Subject: RE: Amole Del Norte Detention Pond [Amole Del Norte Dam (OSE File No. D-577)]

Subject: Amole Del Norte Detention Pond

Subject: Paradise RV Park

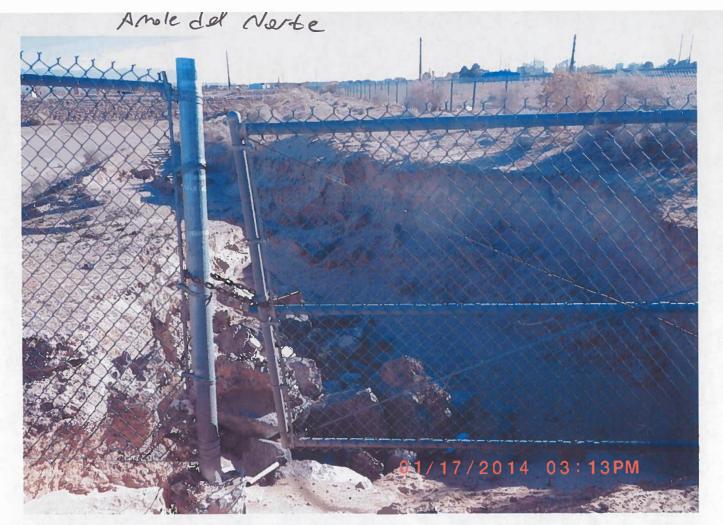
I was out driving around today and figured I'd stop by the 98th st dam and Leonidas Lane since Paradise RV park is under review.

I've attached some photos.

Some of the water draining down Volcano Rd is going into the dam, but some is draining down the outside of the dam on the west side and heading south. The dam was fairly dry and seems it should have had some water in it unless it perks real high.

We have a small project planned at the dam to

- 1) Convey the water from the ROW (that is currently bypassing the dam on the west side) further east in the ROW to the rundown on the north side of the reservoir
- 2) Create a paved swale to keep this same water from entering the facility at the gate and eroding the access road (as it did in 2014 see exhibit)
- 3) Create a water quality structure at the top of the rundown
